Re: Oxbow Development / Coors Pavilion (St. Josephs Dr. / Coors Blvd.)

I will be resubmitting the Traffic Impact Study for the Referenced Oxbow Development / Coors Pavilion project in the future to address both the City's comments as well as the NM DOT comments. For the time being, I will address your comments to the best of my ability in this letter. Your comments were transmitted to me on March 8, 2022 in letter form attached to an e-mail. Below is a summary of your comments and my responses:

| SHEET NO. C-100 | |

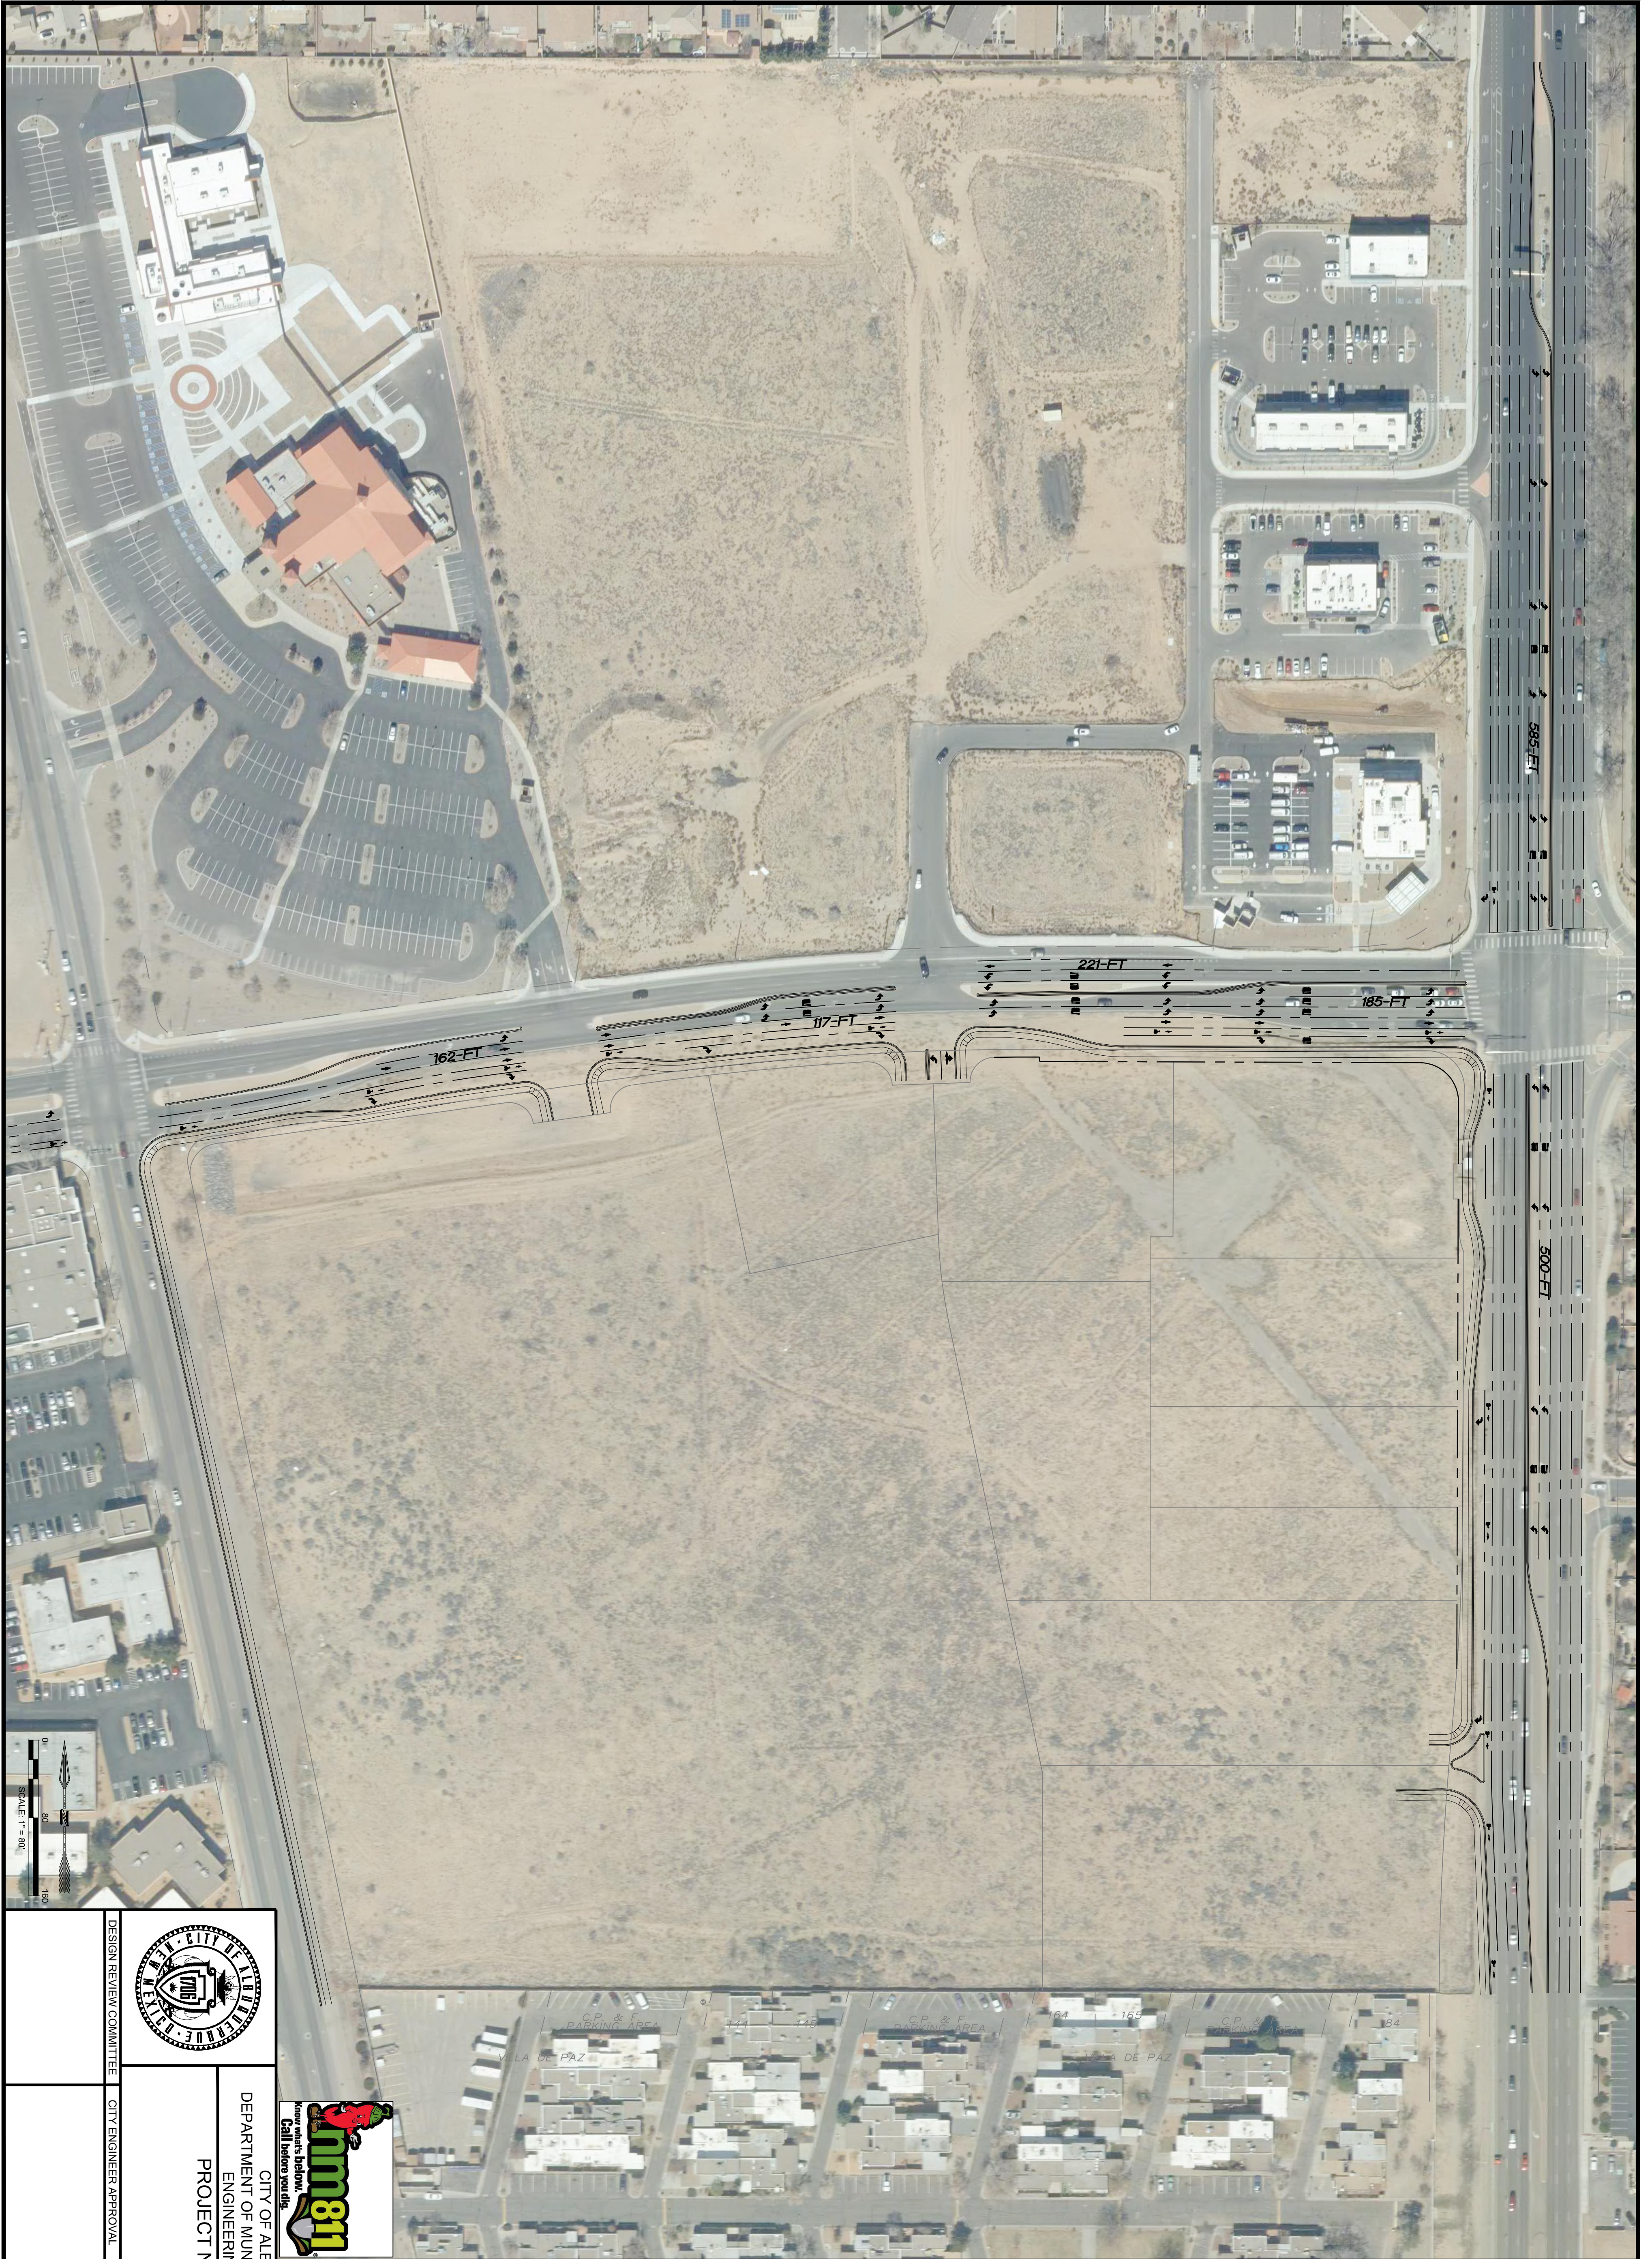
Comment: Provide a conceptual footprint to determine the available ROW and what unforeseen infrastructure impacts are anticipated i.e. traffic signal modifications / relocation ...

Comment: Provide a conceptual footprint of the main entrance to show that it will fit in the existing ROW. Add the eastbound bicycle lane with buffer.

Response: Attached is a graphic conceptual roadway plan developed by Sheldon Greer, P.E. at RESPEC Engineering that demonstrated sufficient ROW available for the recommendations in the TIS.

Response: The attached graphical conceptual roadway plan demonstrates that the main entrance will fit in existing ROW and an eastbound bicycle lane is shown.
